Technical Service Bulletin: TSB250219

Low Temperature Aftercooler (LTA) Water Pump O-ring Oil Leak Countermeasure

QST30 CM552

Figure 1, Example of LTA water pump mounting o-ring seal

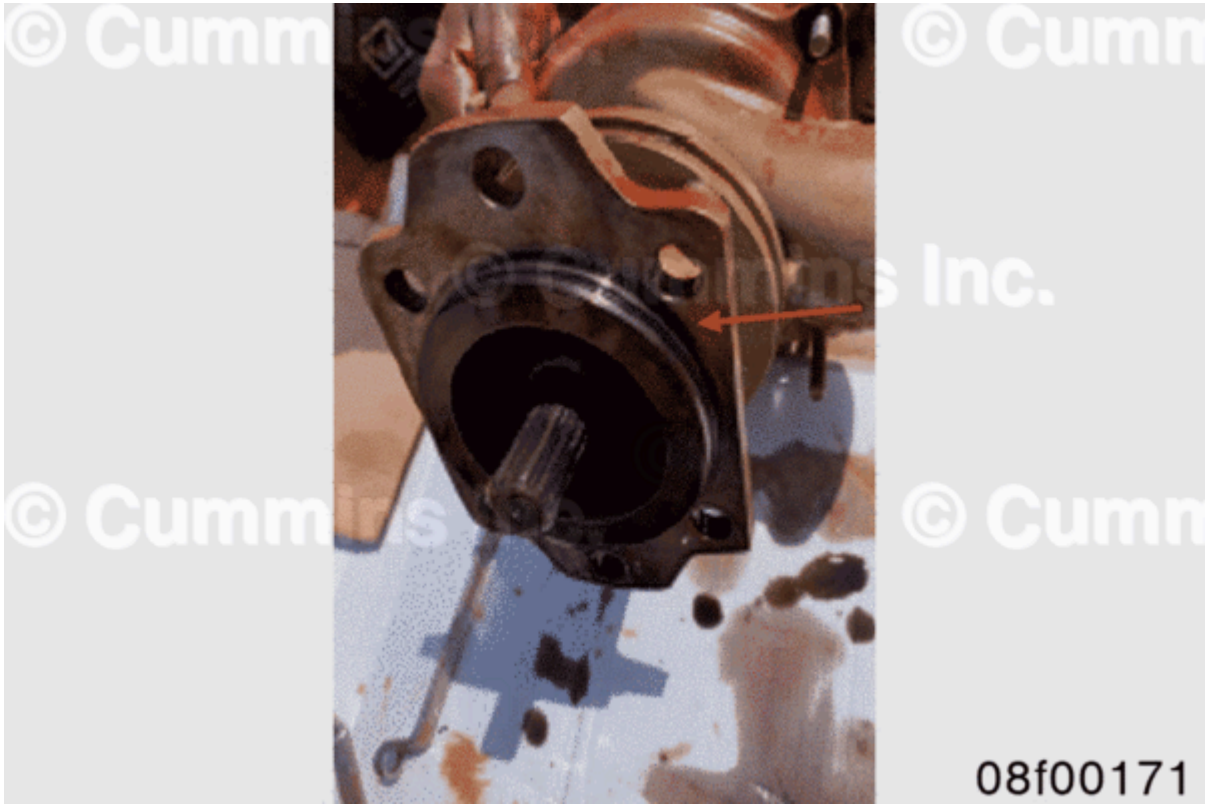
- External oil leak from the LTA water pump-to-accessory drive joint.

- The o-ring seal of this joint experiences temperature exposure beyond its material capabilities.

As a countermeasure for this issue, replace failed seal part number 4025376 with seal part number 3033248, which has higher temperature exposure capabilities. See image 1 for referenced o-ring seal.
